City of Sandy

Planning Commission Meeting
Meeting Location: Virtual via Zoom
Meeting Date: Monday, October 25, 2021
Meeting Time: 6:30 PM

**PLANNING COMMISSION STAFF REPORT
TYPE III LAND USE PROPOSAL**

EXHIBIT C "THE BORNSTEDT VIEWS"

PROJECT: **THE BORNSTEDT VIEWS GRADING AND EROSION CONTROL PLAN**

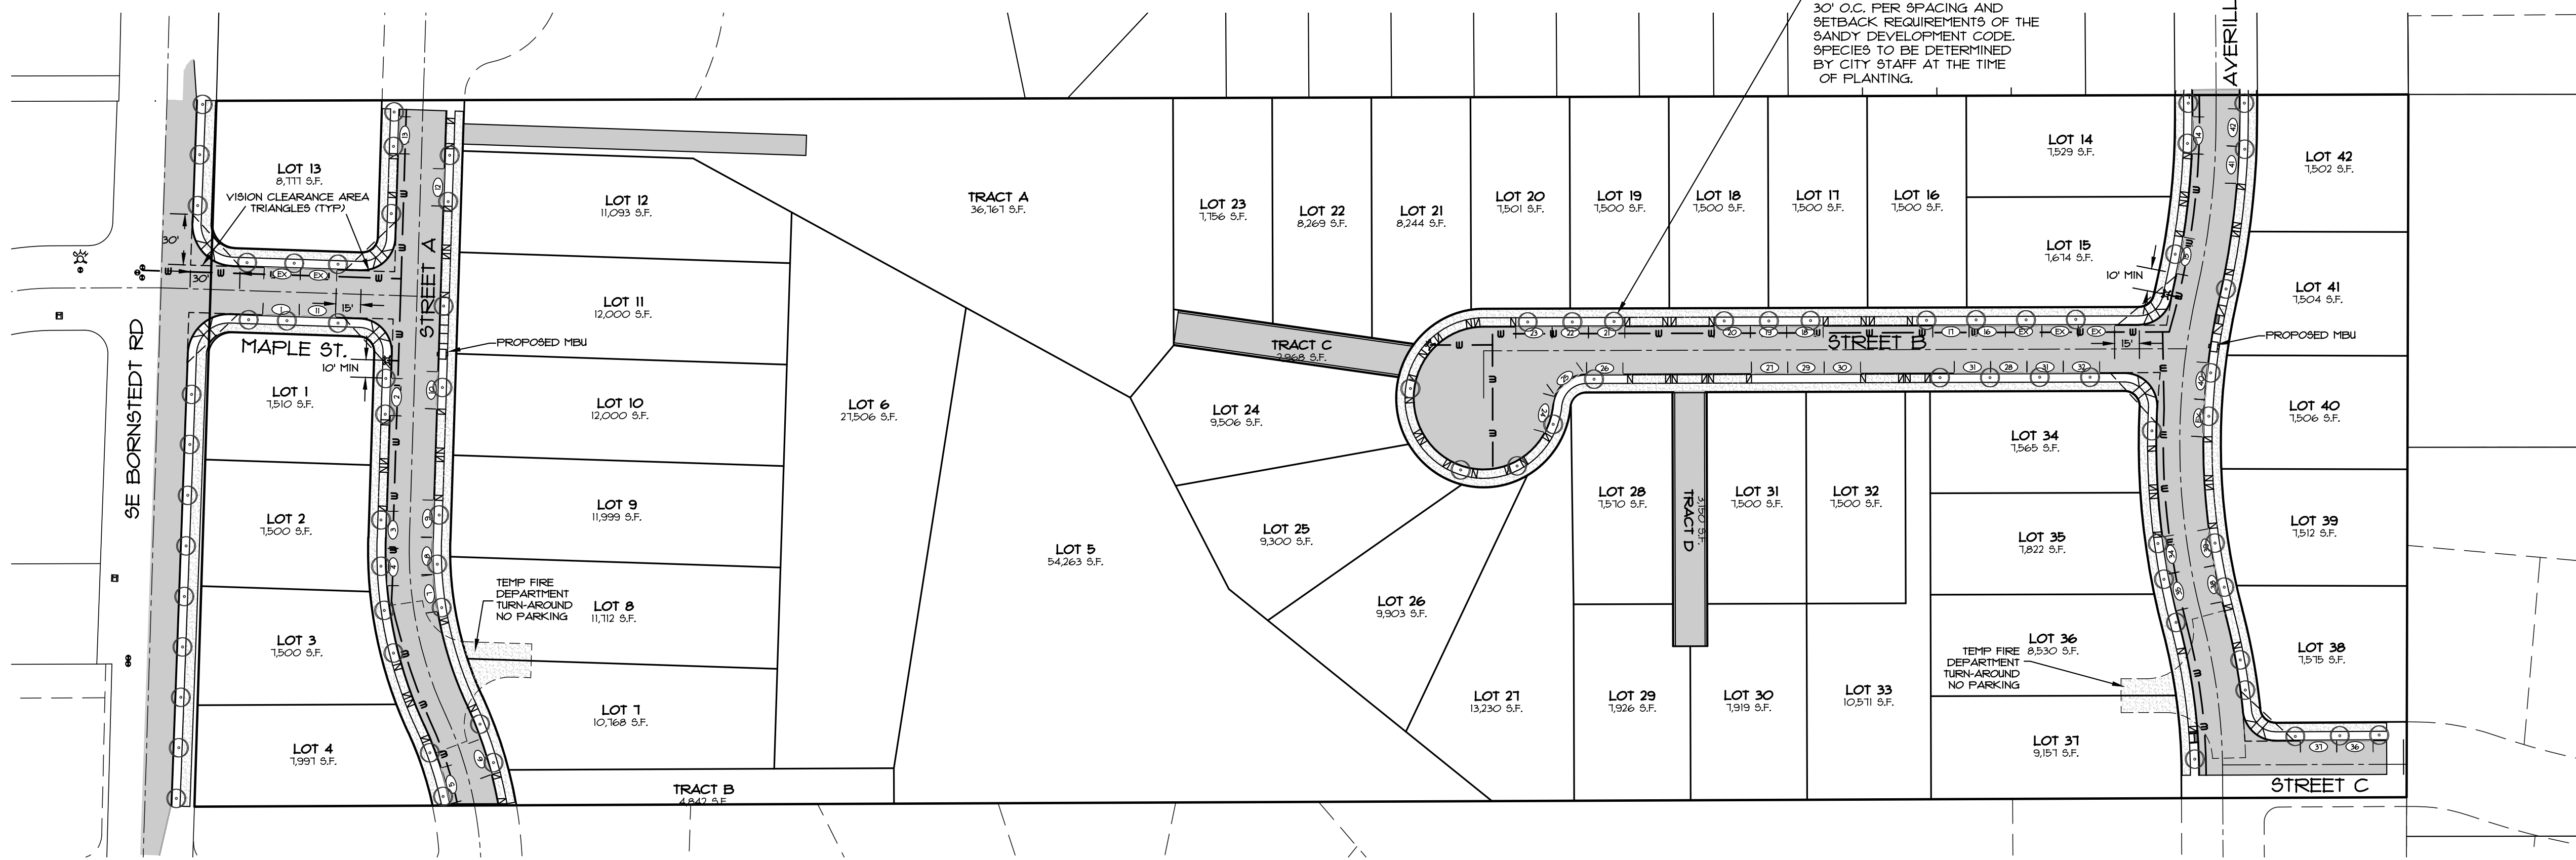
86. Grass seeding shall be completed as required by Section 17.100.300. The submitted preliminary Grading and Erosion Control Plan (Exhibit C, Sheet C9) provides additional details to address erosion control concerns. A separate Grading and Erosion Control Permit will be required prior to any site grading. Erosion control requirements are defined in greater detail in Chapter 15.44 of this document. Section 15.44.50 contains requirements for maintenance of a site including re-vegetation of all graded areas. **The applicant's Erosion Control Plan shall be designed in accordance with the standards of Section 15.44.50.**

BY	REVISION	SHEET
		C10
		OF 10
DATE	DESIGNED: RLM	
	DRAWN: RLM	
	CHECKED: DLH	
	APPROVED: RLM

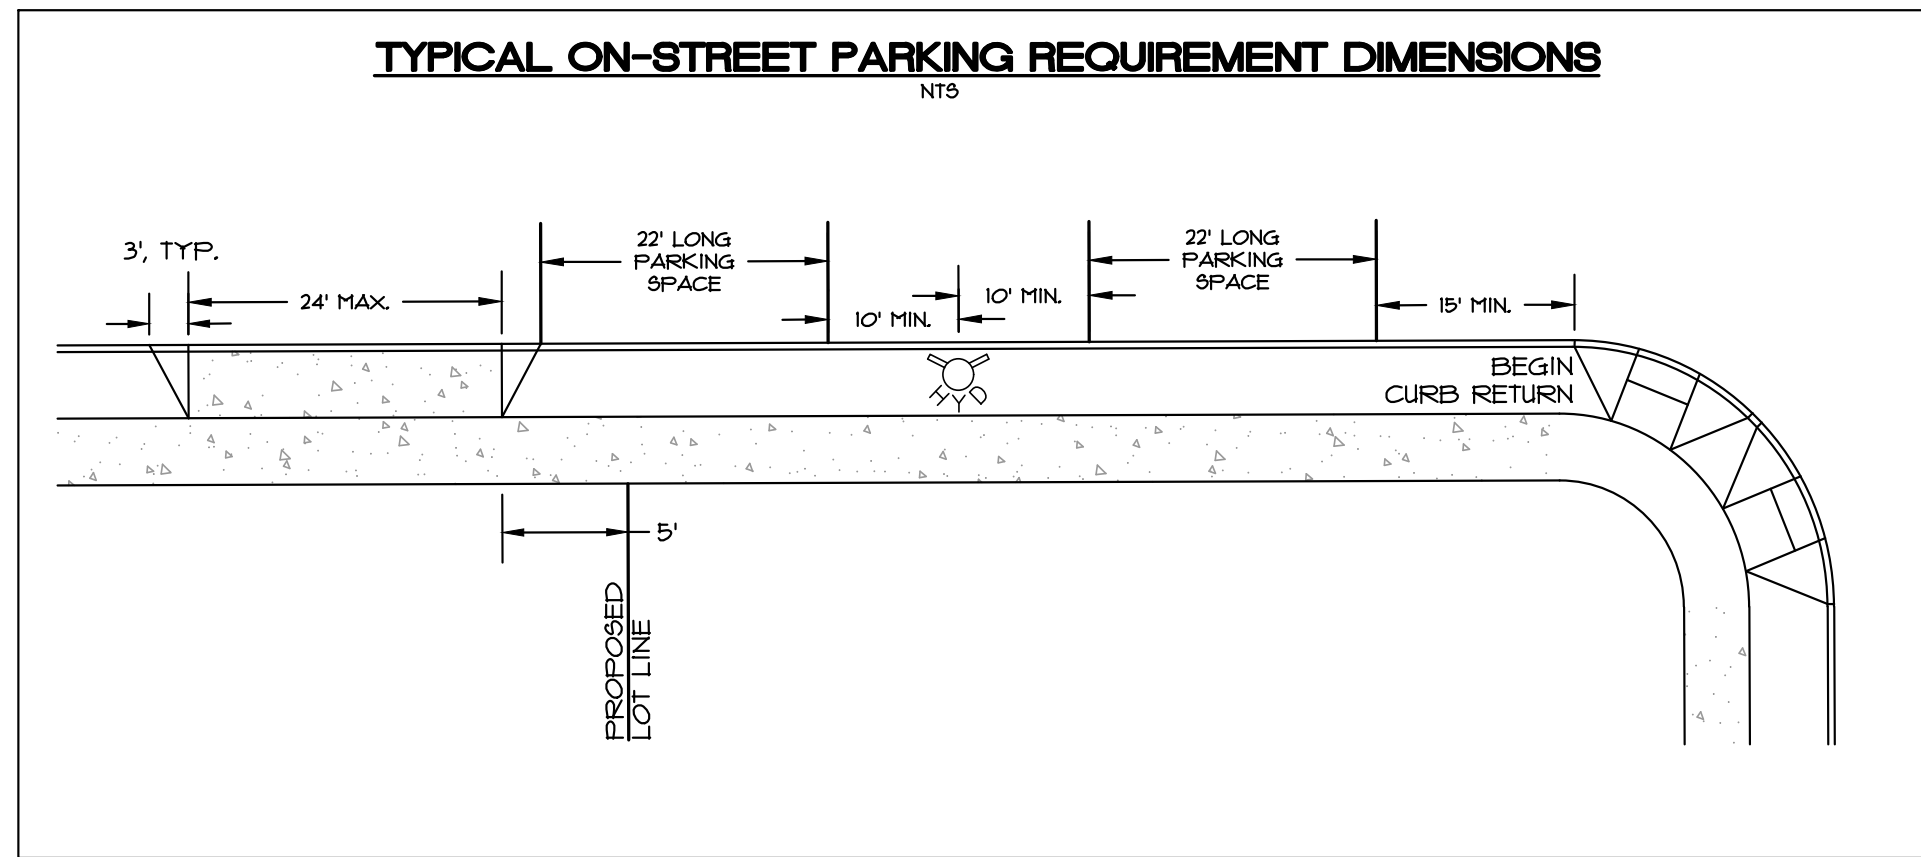
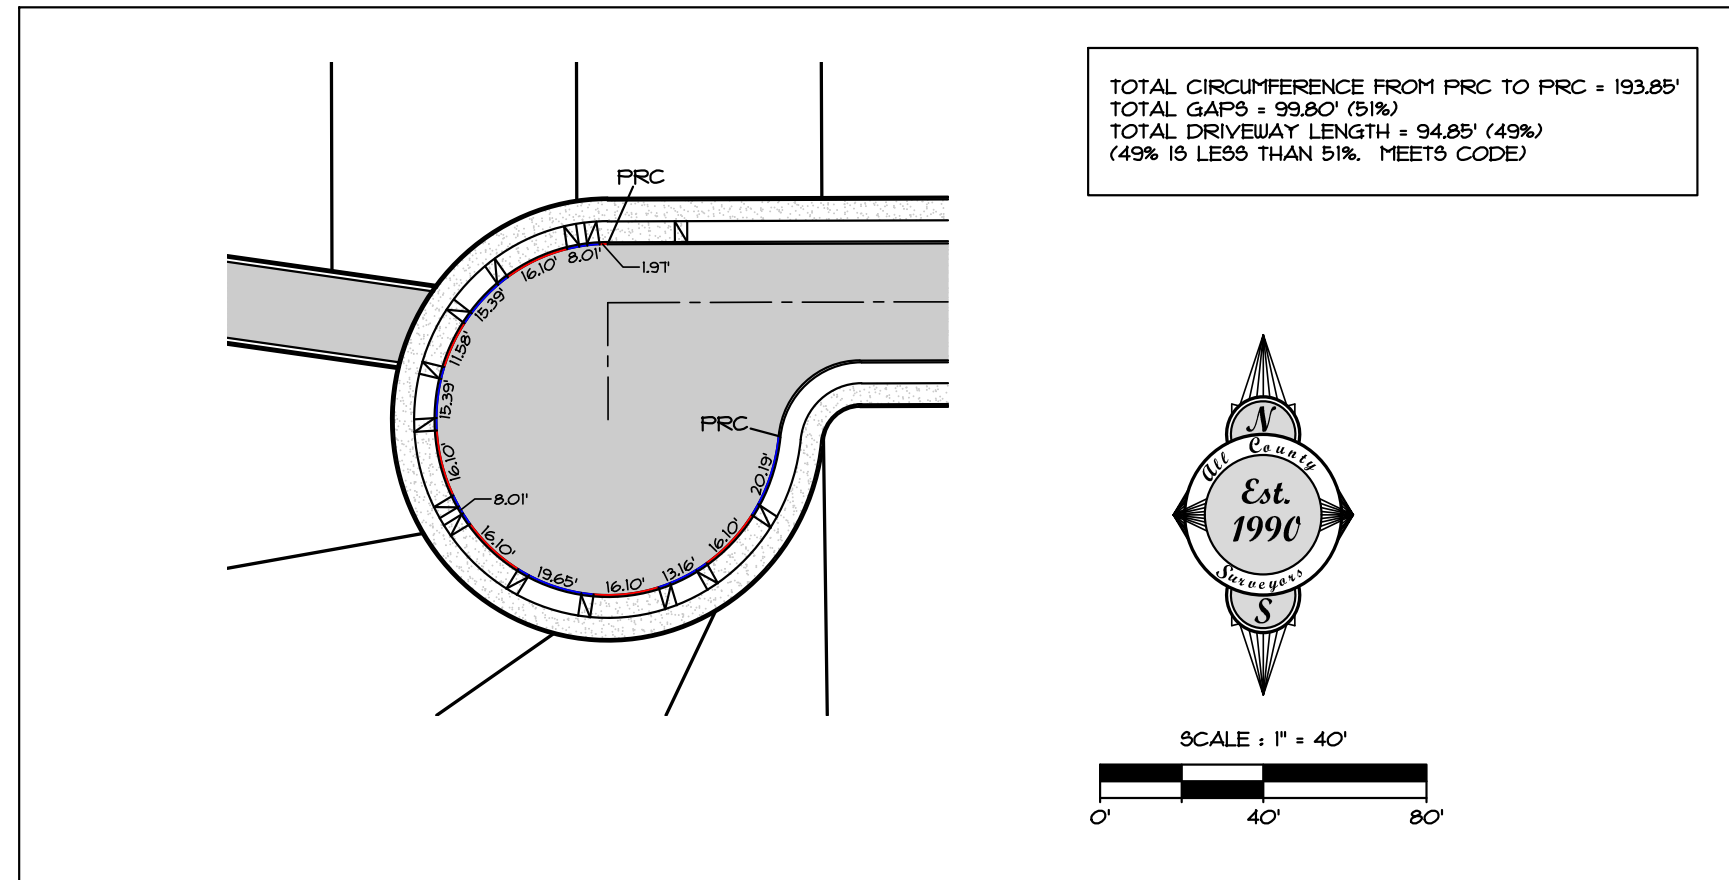
78. Section 17.92.30 states that planting of trees is required for all parking lots with four or more parking spaces, public street frontages, and along private drives more than 150 feet long. The applicant submitted an On-Street Parking Plan (Exhibit C, Sheet C10) that details street trees. The applicant's proposal includes three (3) private drives, one of which is more than 150 feet long (Tract B). The On-Street Parking Plan does not detail trees along Tract B; therefore, the proposal does not meet the requirements of Section 17.92.30. However, as discussed in detail in Section 17.100.150(A) of this document, the applicant also did not submit sufficient evidence to justify the use of private drives. In addition, the proposed lots that gain access from the private drives do not meet the minimum frontage requirements of Section 17.34.30(C). Therefore, Tracts B, C, and D do not meet the code and staff does not support the proposal for private drives. However, **if the application is approved as submitted, street trees shall be planted approximately 30 feet on center in a minimum 5 foot wide planter strip on any private drives more than 150 feet per Sections 17.92.30 and 17.92.10(D).**

79. Section 17.92.30 specifies that street trees shall be chosen from the City-approved list. As required by Section 17.92.30, the development of the subdivision requires medium trees spaced 30 feet on center along all street frontages. Planter strips will be provided along all frontages as required in Section 17.100.290. The submitted On-Street Parking Plan (Exhibit C, Sheet C10) includes a note that states street trees will be planted 30 feet on center. The note also states that species will be determined by City staff at the time of planting. If the Planning Commission approves the application, **the applicant shall submit proposed tree species to City staff for review and approval concurrent with construction plan review. Due to concerns with Asian Longhorn Beetle and Emerald Ash Borer as well as an interest in increasing species diversity, staff are not approving maples or ashes as street trees at this time. To improve species diversity, the applicant shall include at least four (4) different tree genera, with at least two (2) different genera per block face.**
